## ADDENDUM NO. 1

May 29, 2025

Leggett Volunteer Fire Department & Town Hall  
29 Draughn Rd  
Tarboro NC 27886

- 1 – Pre-Bid Meeting Key Notes – Dated 05-15-2025
- 2 – Pre-Bid Meeting Sign-in Sheet – Dated 05-15-2029
- 3 – RFI Log – Dated 05-29-2025
- 4 – Revision 1 Sheets – Dated 05-15-2025
- 5 – Revision 2 Sheets – Dated 05-29-2025

4 STARTER TREAD DETAIL @ INTERIOR  
SCALE: 1 1/2" = 1'-0"

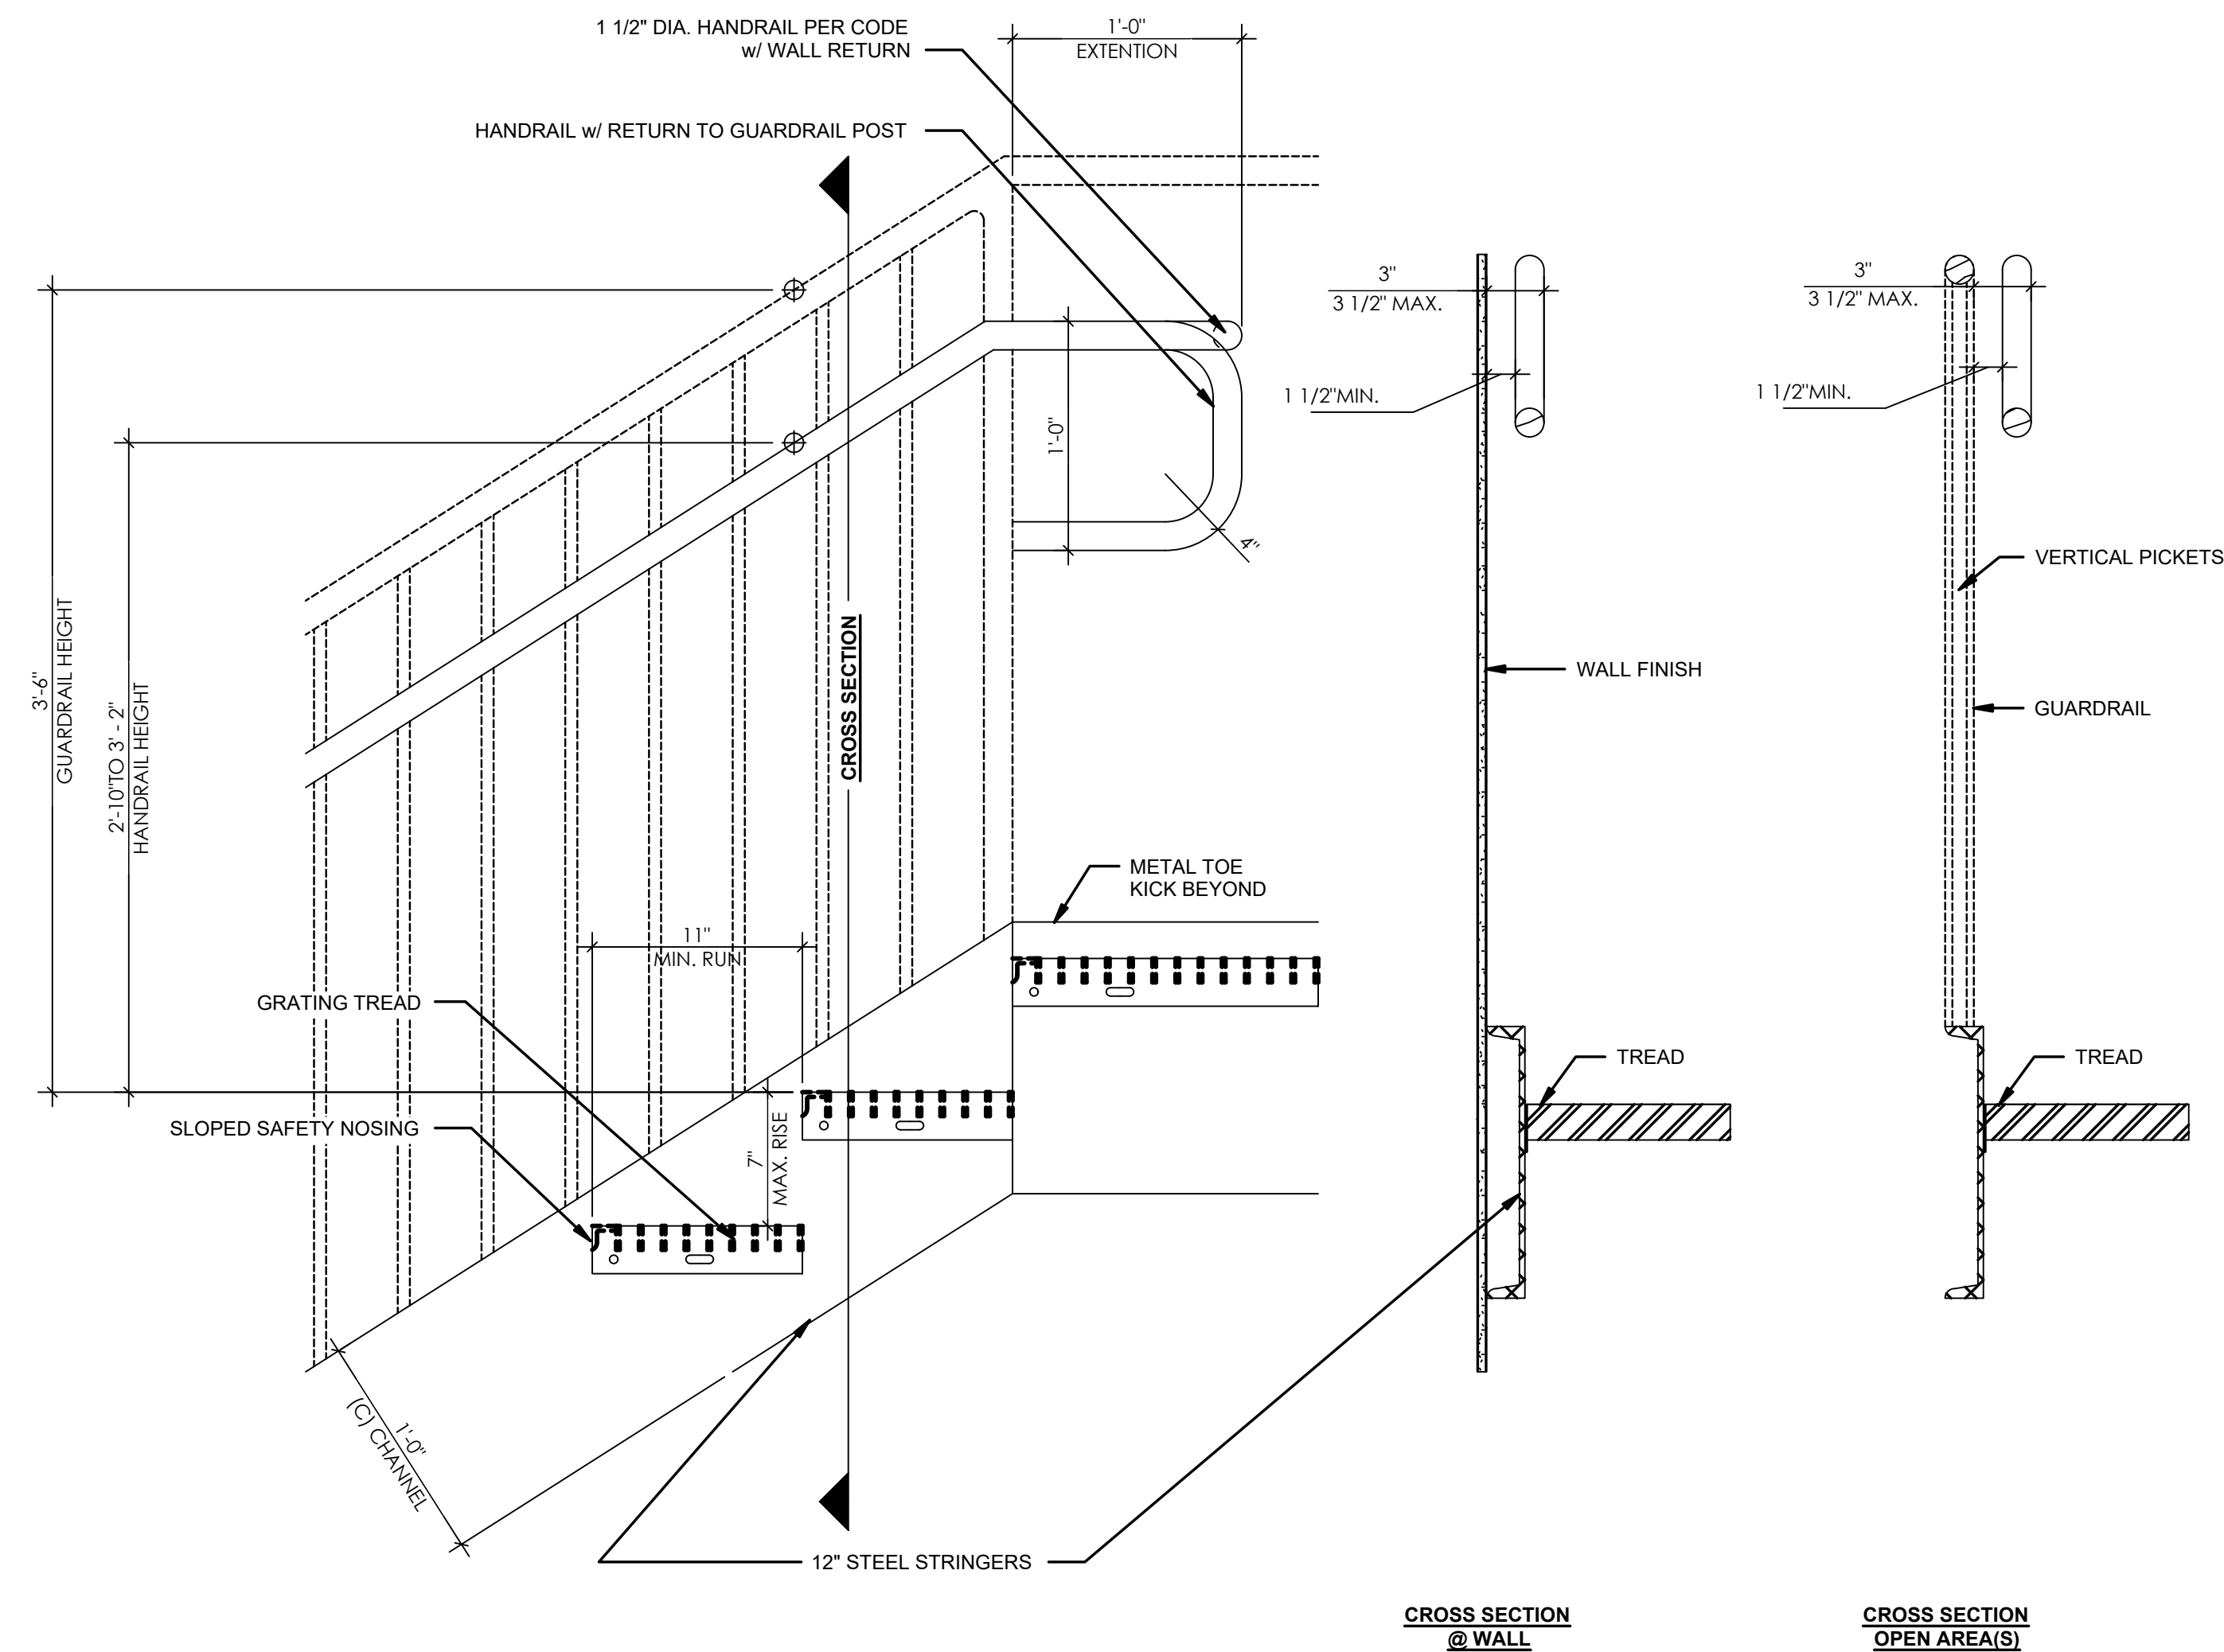
14	The interior stair shows an LVL stringer with concrete treads and the detail shows grated treads also. Can we figure that out as well.	Stairs in truck bay to be grated, interior stairs should be wood. See Revision 2 sheets.
15	The plans are locked to where I cannot scale them to figure out the channel size for the stairs. Please let me know if we can get that fixed.	We are unable to send out unverified plans.
16	Could the project schedule be extended to 13 or 14 months?	Project duration to be 13 months. If alternate no 2 is accepted, project to remain at 11 months.

ALL STAIR DETAILS ON THIS SHEET ARE FOR THE INTERIOR STAIRCASE LOCATED IN TRUCK BAY
